**TITLE:** **CHANGE OF ZONE NO. 05004A**, an amendment to the **Pine Garden Planned Unit Development**, requested by Lenity Group and Realty Trust Group, on property generally located northwest of the intersection of South 84<sup>th</sup> Street and Old Cheney Road.

# LINCOLN CITY/LANCASTER COUNTY PLANNING STAFF REPORT

- PROJECT #:** Change of Zone #05004A - Pine Garden Planned Unit Development (PUD)
- PROPOSAL:** Replace 28 dwelling units with a 66-bed memory care facility and reduce the total commercial floor area from 25,300 to 17,420 square feet.
- LOCATION:** Northwest of the intersection of South 84<sup>th</sup> Street and Old Cheney Road
- LAND AREA:** 5.87 acres, more or less
- WAIVERS:** 1. Adjust cul-de-sac radius for South 83<sup>rd</sup> Street from 60 feet to 35 feet.
- CONCLUSION:** Subject to the recommended conditions of approval, this request conforms to the Comprehensive Plan, Zoning and Subdivision Ordinances.

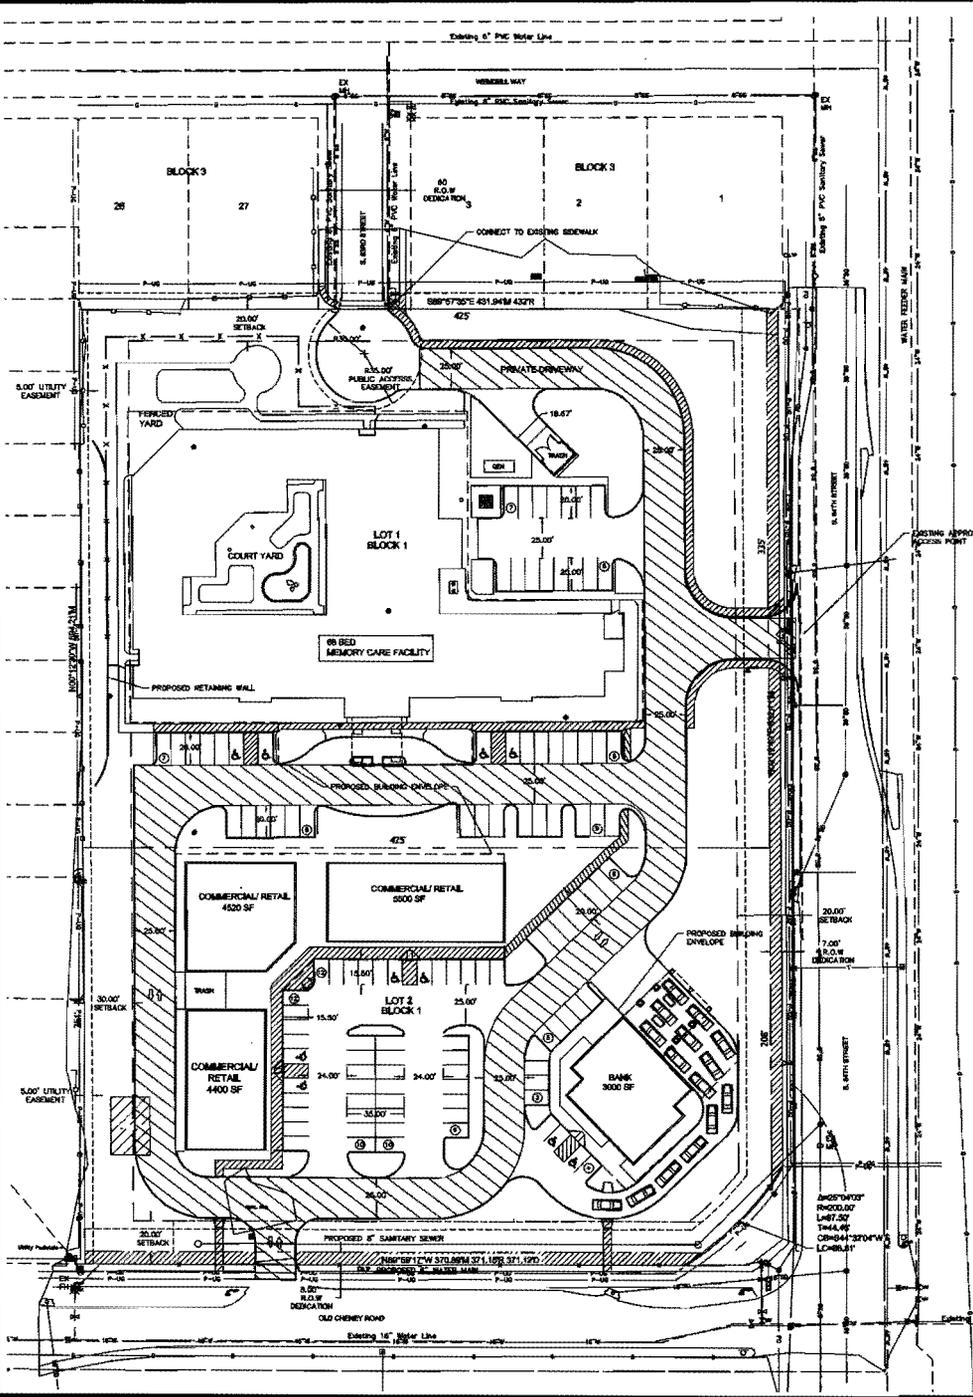
- 1.1 Revise the plans as follows:
    - 1.1.1 Add a note which states “Sidewalks shown are conceptual, but will be provided in compliance with Design Standards at the time of Building Permit.”

- 1.1.2 Revise Note #7 to state “Signs need not be shown on the plan, but will be reviewed at the time of sign permit in compliance with LMC 27.69.340.

- 1.1.3 Delete Notes 8, 9 and 13 which are redundant.
    - 1.1.4 Delete “Private Roadways” from Note #12 as none are shown on the plan.
    - 1.1.5 Delete Note #15 which contains a timing provision not required by the PUD.

- 1.1.6 Revise Note #17 to reference South 83<sup>rd</sup> Bay.
  - 1.2 Submit revised grading, drainage, and utility plans to the satisfaction of Public Works and Utilities.
